ASSESSMENT REPORT

Limondale Solar Farm

Panel Height and Subdivision Modification (SSD 8025 MOD 1)

Figure 1: Proposed solar module tracking system dimensions

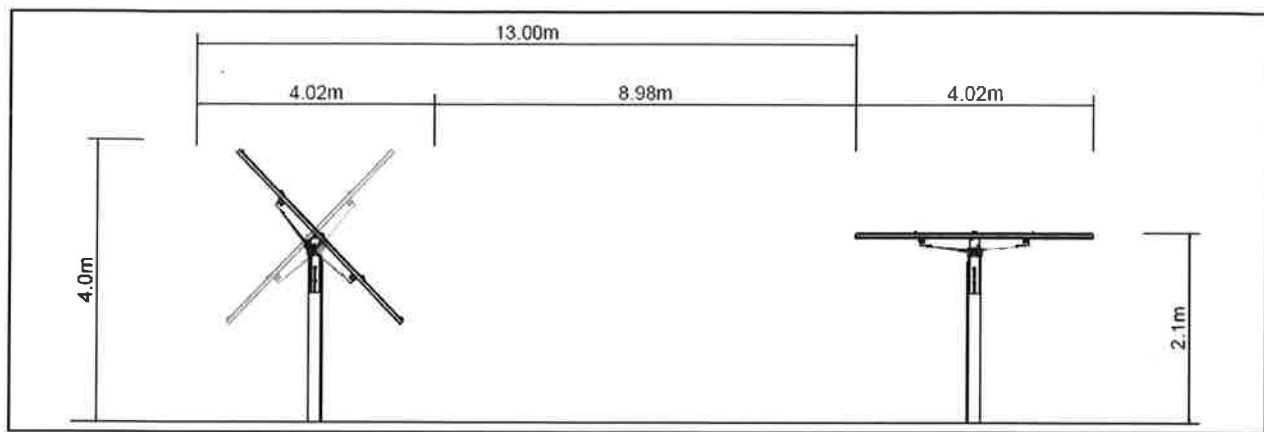
Accordingly, the Applicant is seeking to modify the development consent to increase the maximum height of the solar panels from 2 m to 4 m. This would include a height increase to the solar tracking base frame from 1.2 m to 2.1 m, and utilises an alternate panel arrangement on each tracking row. No additional works are proposed in areas outside the approved development footprint.

As the solar panels would be built on a single axis tracking configuration to track the trajectory of the sun, the maximum proposed solar panel height of 4 m would typically only occur during early morning and late afternoon periods (see **Figure 1**).

Figure 2: Project layout, residence and subdivision location

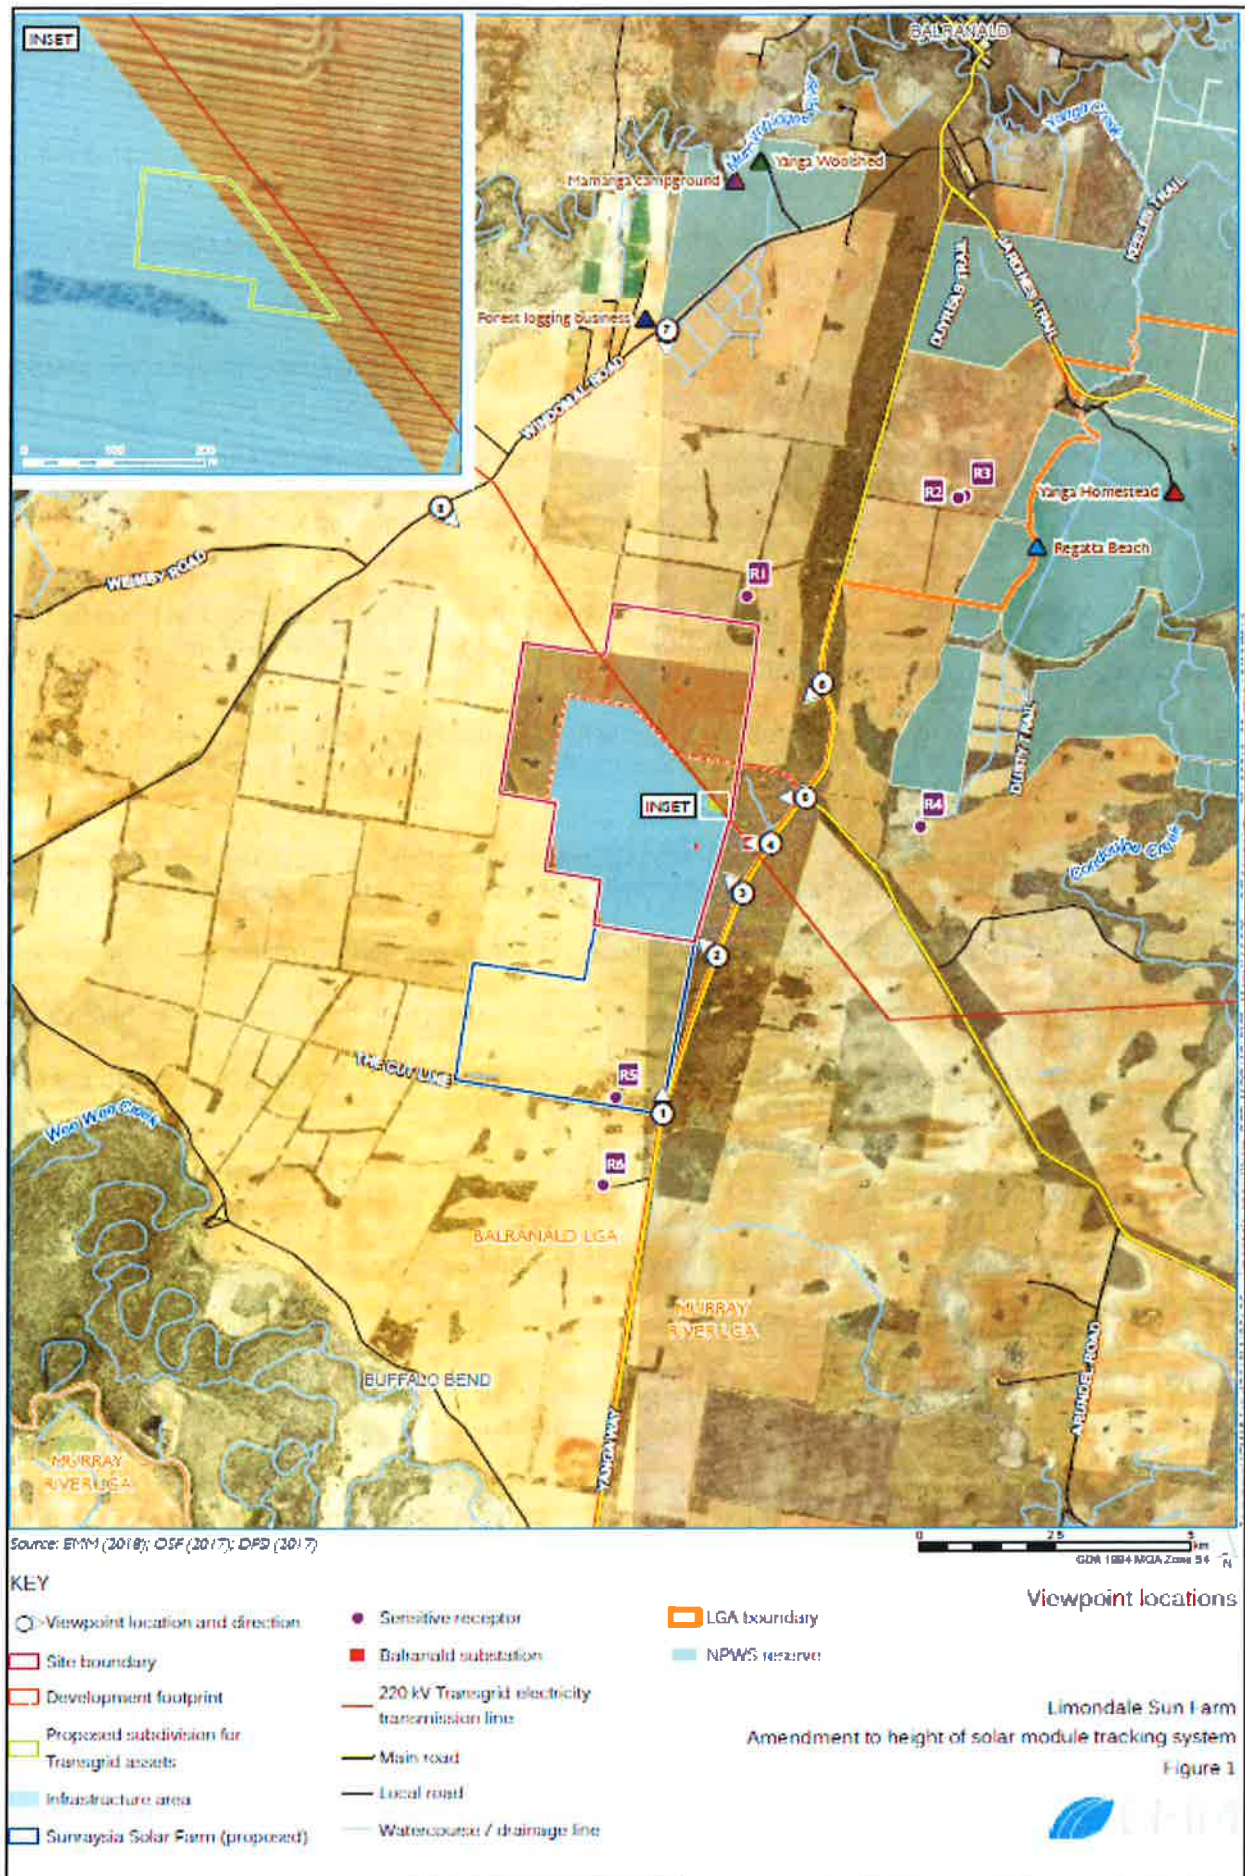
The project site is set in a semi-rural setting along Yanga Way, with 16 residences located within 6km. The nearest residence, R1, is located approximately 3 km to the project's north-east (see **Figure 2**).

The Applicant undertook a visual assessment of the proposed 4 m high panels using the same representative viewpoints as assessed for the approved project. The assessment concluded that there would be minor increases in visibility along portions of Yanga Way and at the nearest residence, R1.

The lots proposed to be subdivided are located on land zoned RU1 - Primary Production under the *Balranald Local Environmental Plan (LEP) 2010*. The proposed lots resulting from the subdivision would be below the minimum lot size of 40 ha for land zoned RU1.

As no additional works are proposed in areas outside the approved development footprint, the Department considers the visual impacts of the modified project to be minor and is satisfied that the proposed modification would not result in any significant increase in the environmental or amenity impacts.

As such, the Department supports the Applicant's request to subdivide the land.
